A G E N D A

Architectural Review Board

March 23, 2021 – 5:30 p.m.

SITE PLAN TO SCALE
3236 CLOVERDALE RD.

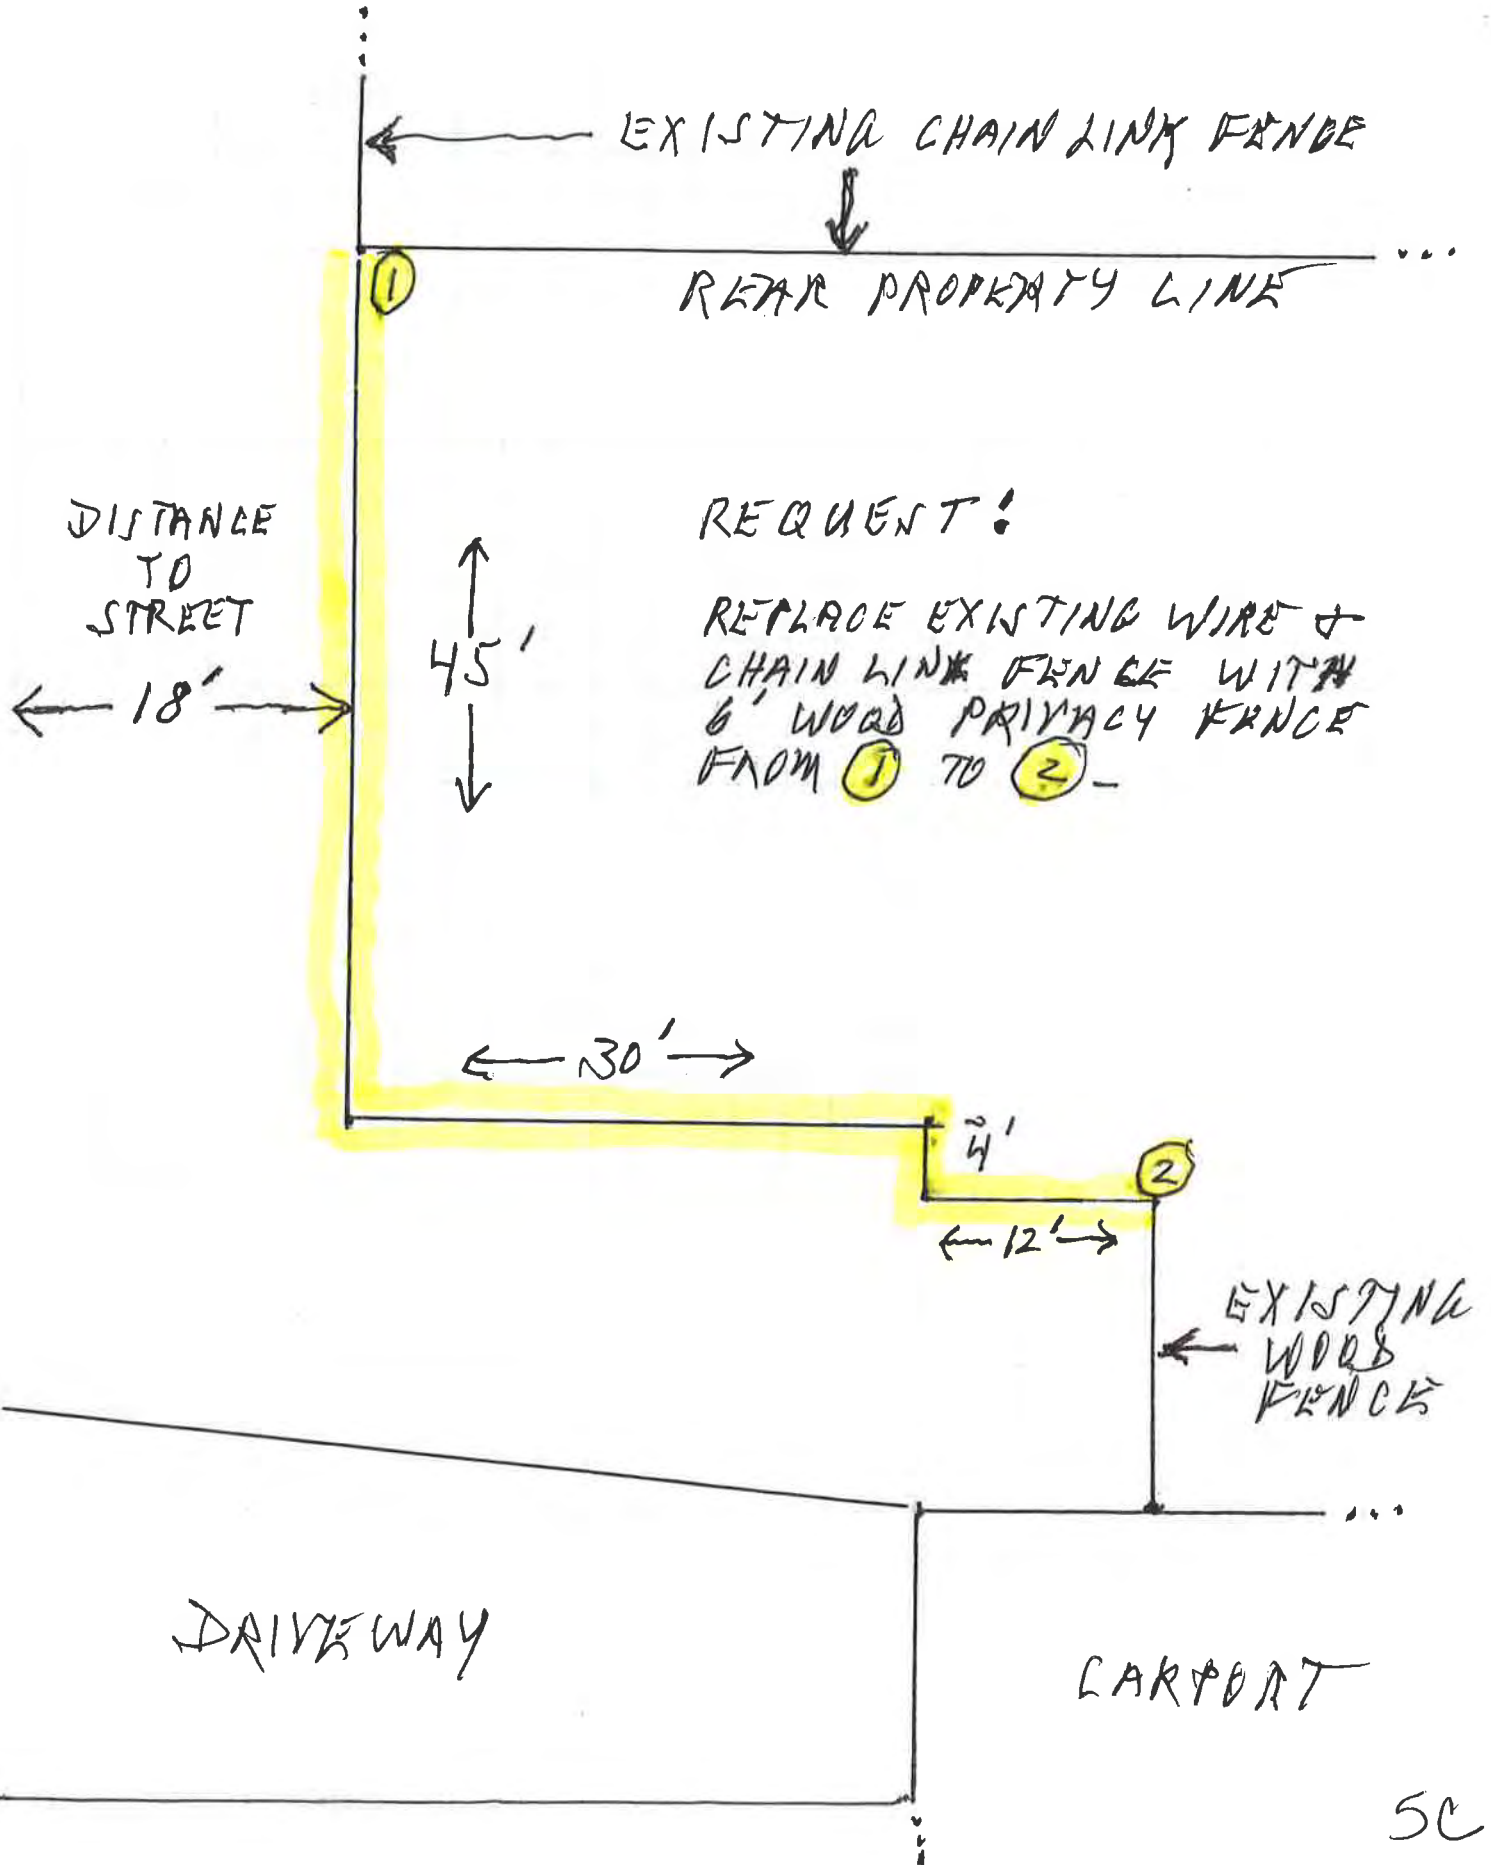
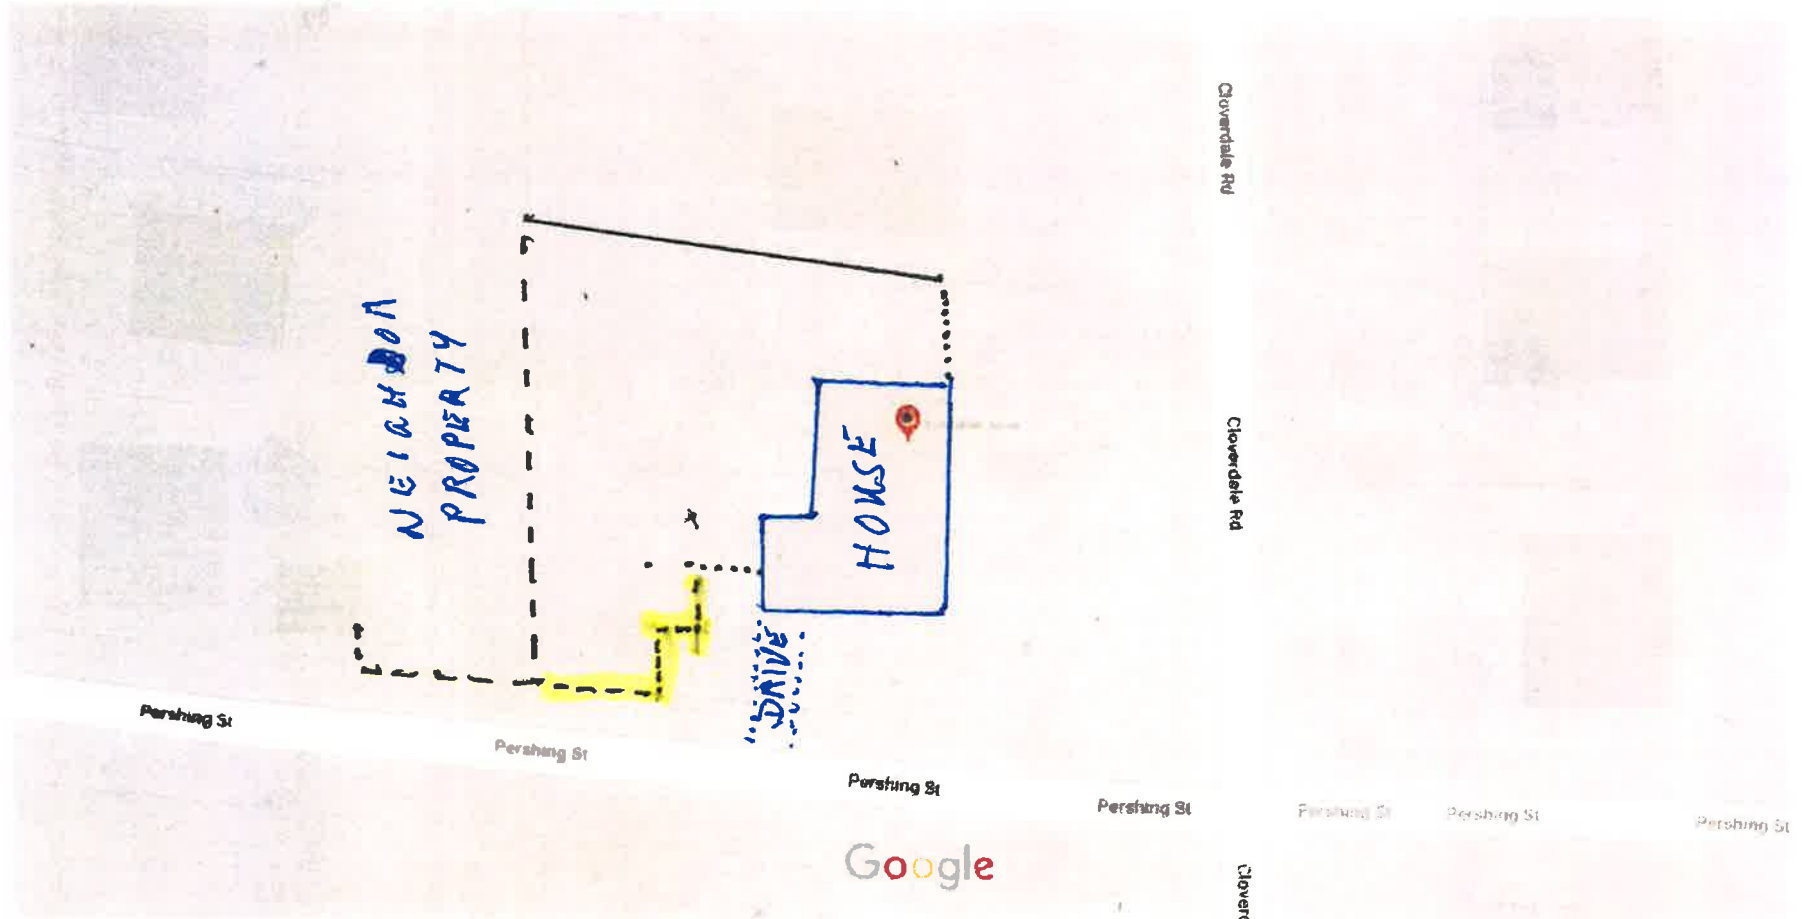
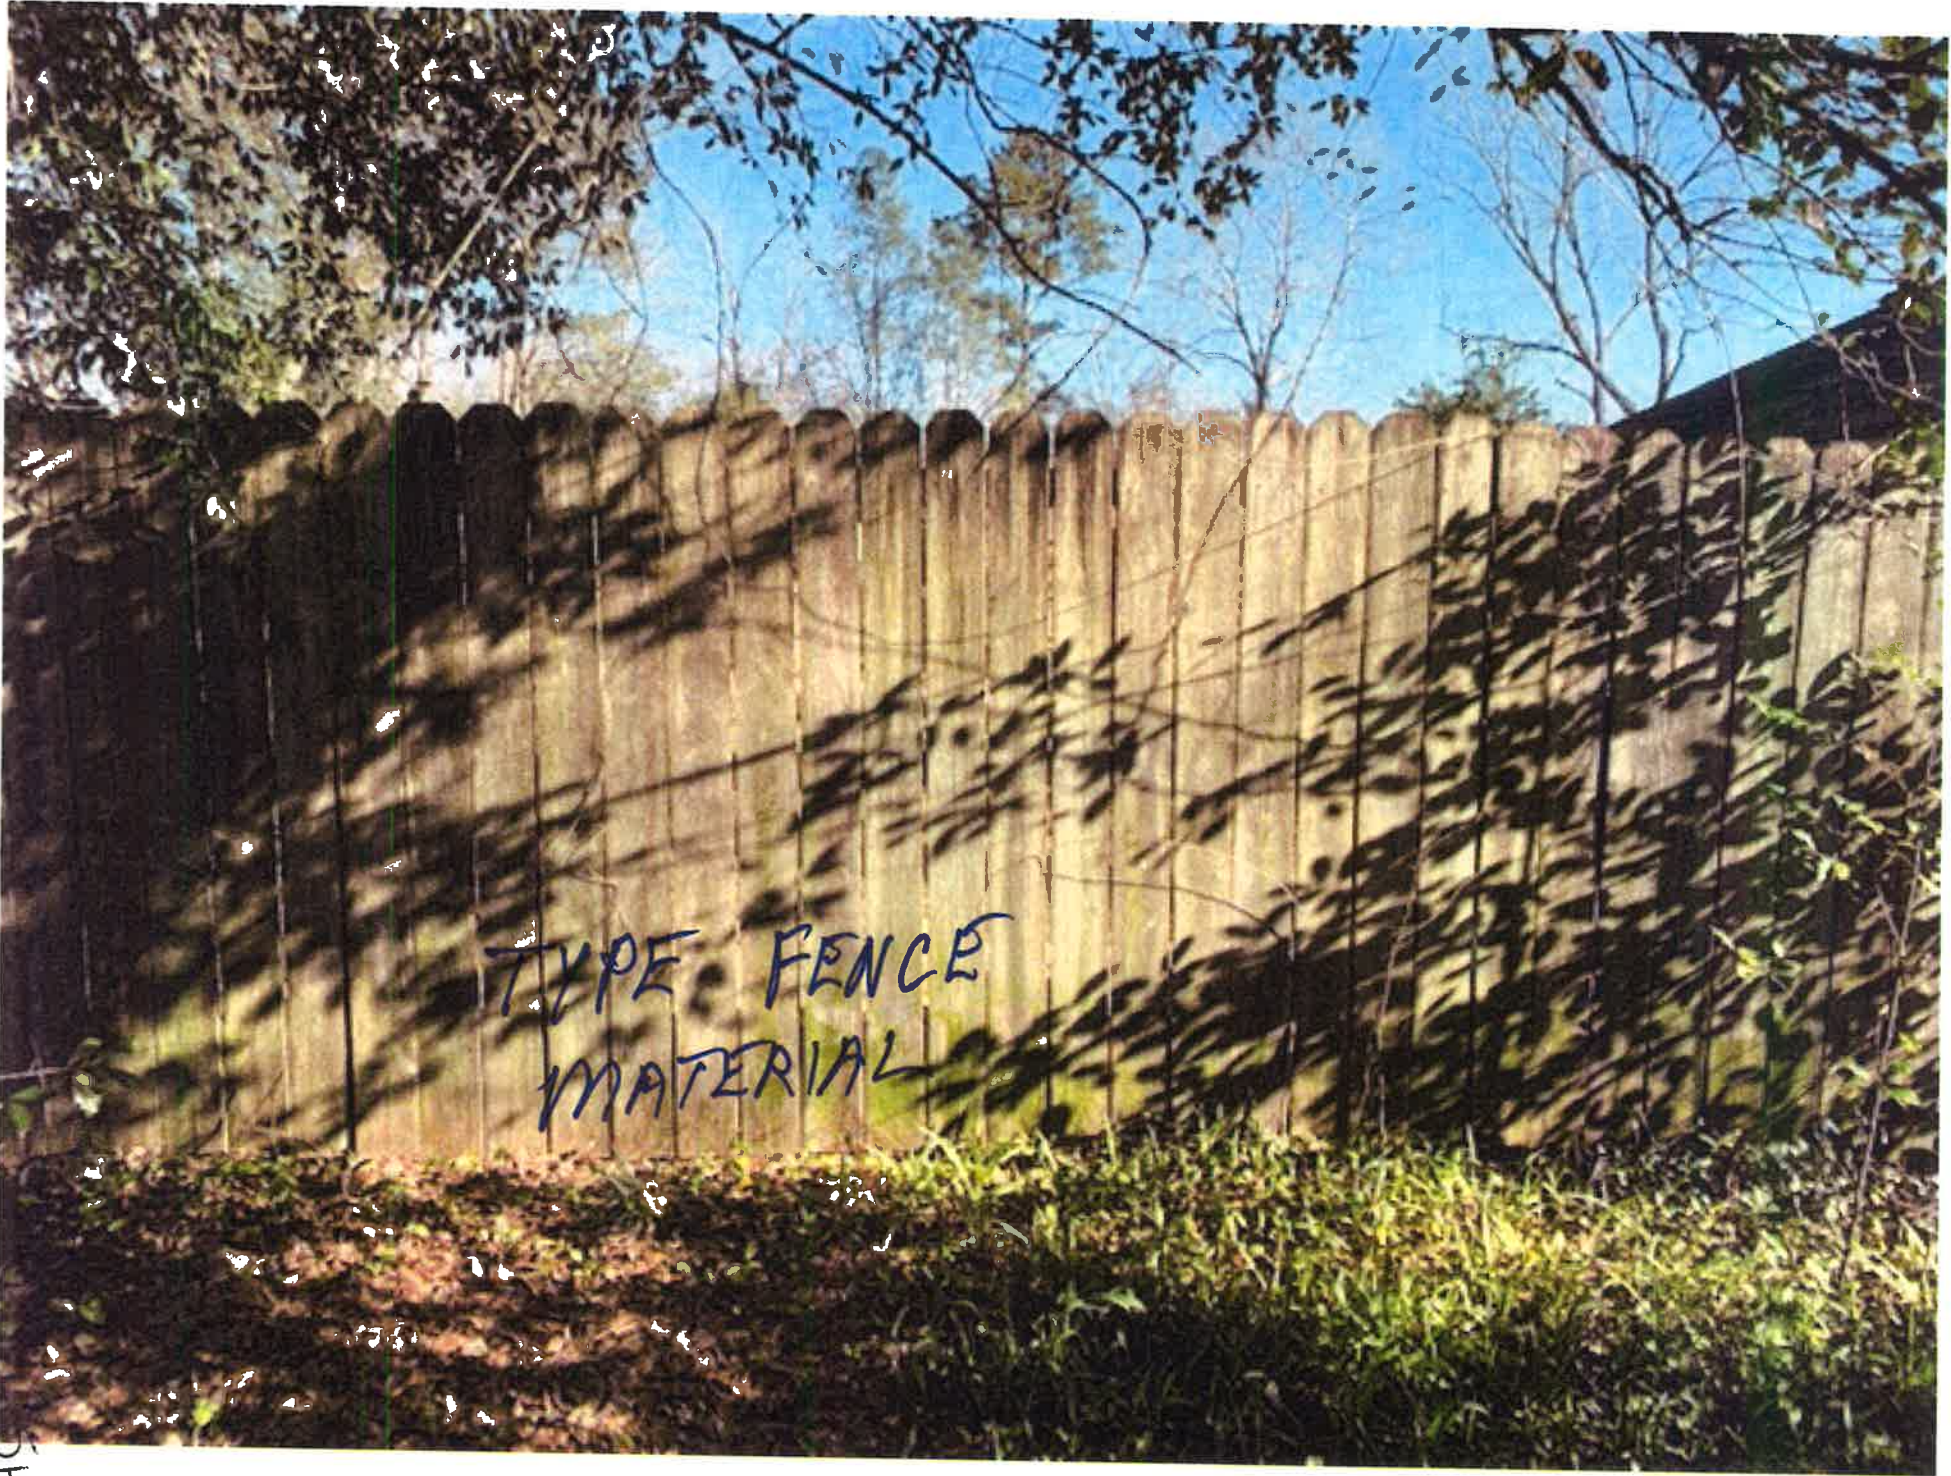
- This will be far less obtrusive than the fence directly across the road, no objection.

3328 Le Bron Road

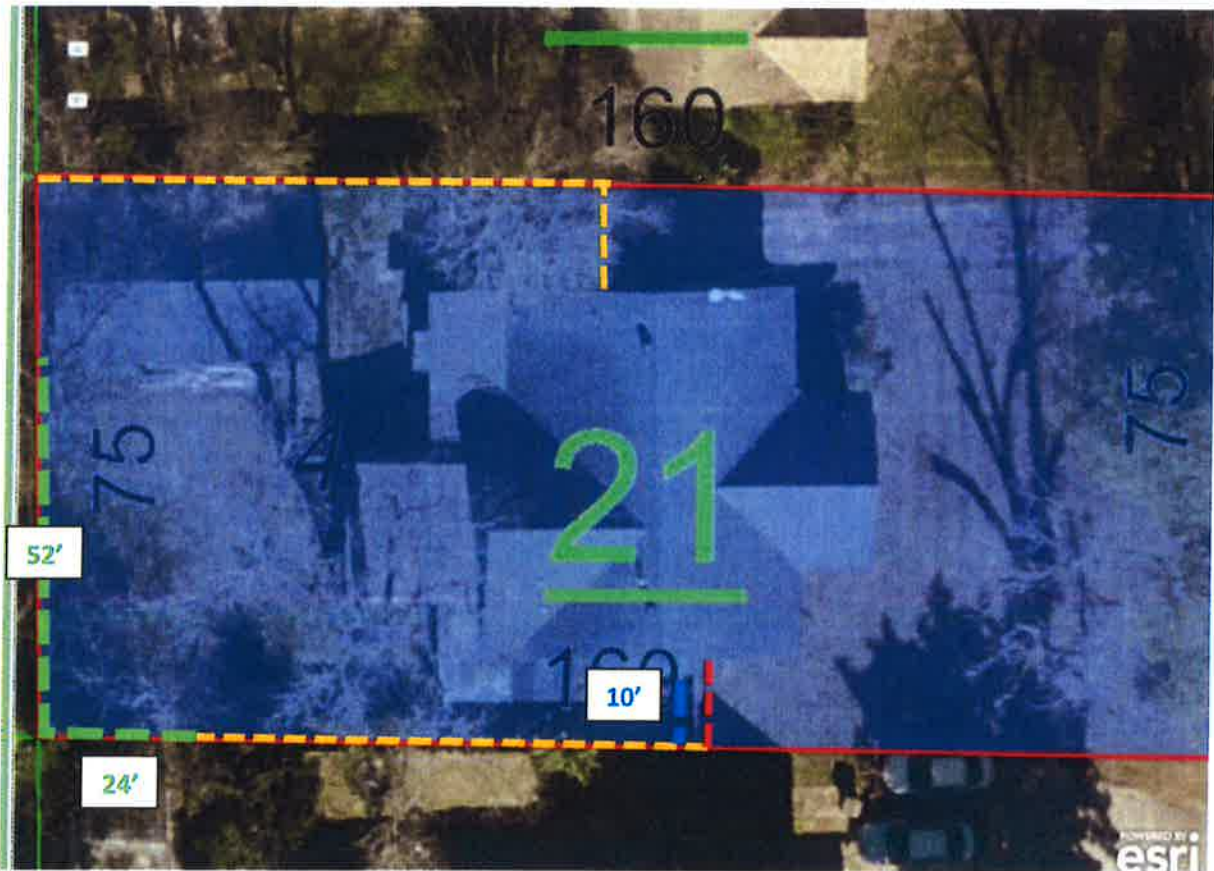
- No objection to the fence proposal.
- If approved, if the gable vents are in good shape I hope they'll find a good home to be reused.
- A 12 lite window might be a bit ambitious in that space, a 6 lite might feel less crowded.

601 E. Fairview Avenue

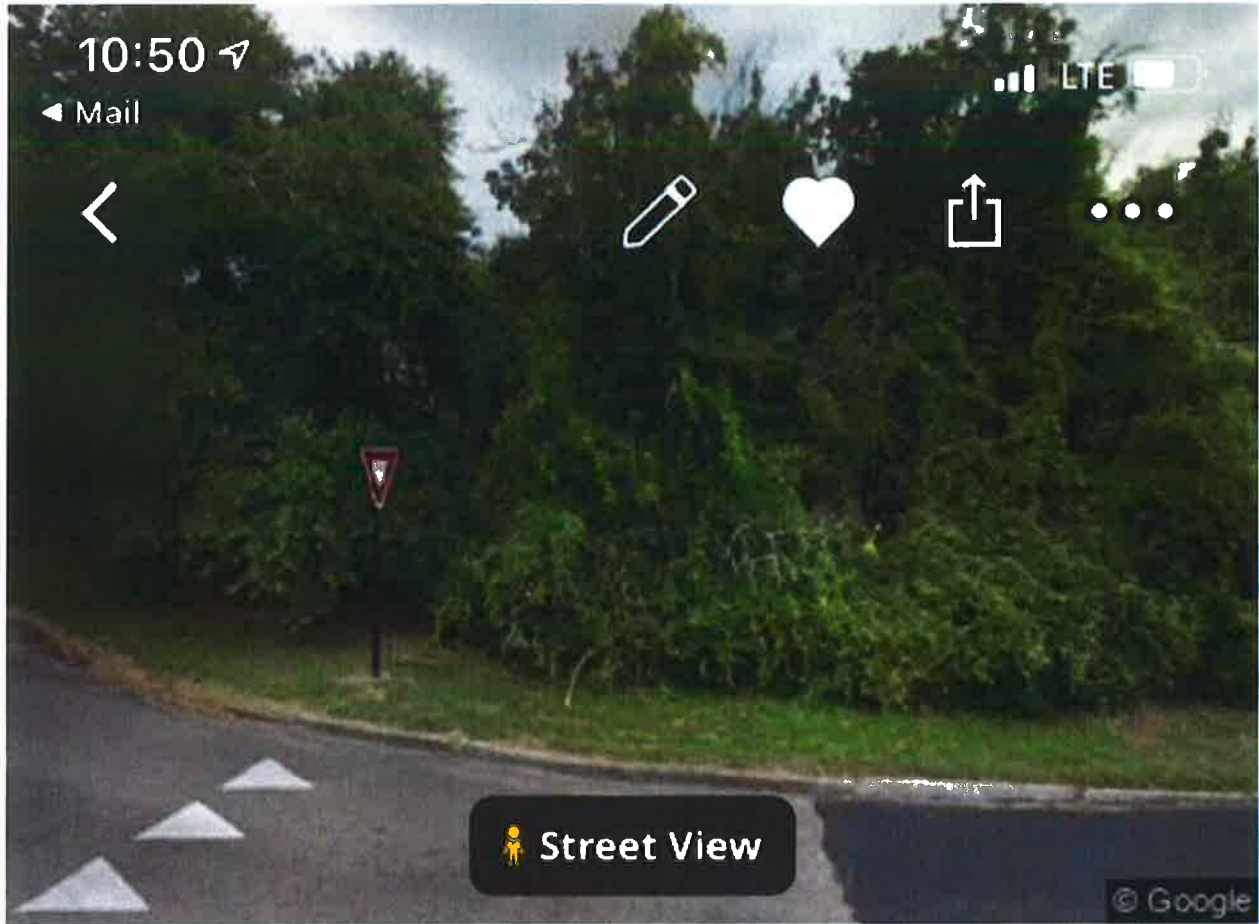
- No objection to the fence.
- This is a high style Tudor revival house that would have typically been unpainted. The Board denied a petition in the Garden District pending necessary exterior repairs to that house, at which time the Board said it could be reconsidered. In this case, alterations have been made to the structure by filling in existing openings (windows and garage doors). To keep the alterations distinguishable from the original part of the building, we would want to see that this was indeed constructed as a garage. Painting would remove most visual

9F

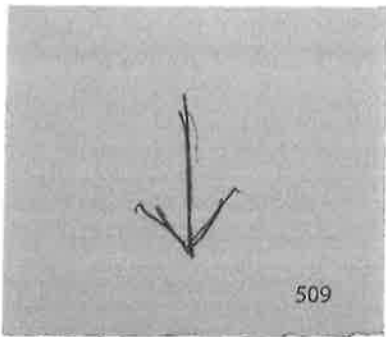
- The Board could approve the roof structure as proposed on the condition that should this solution to the water issue be unsuccessful that the structure needs to be removed and any other visible/structure based solutions need to be brought before the Board.
- No objection to the fence.
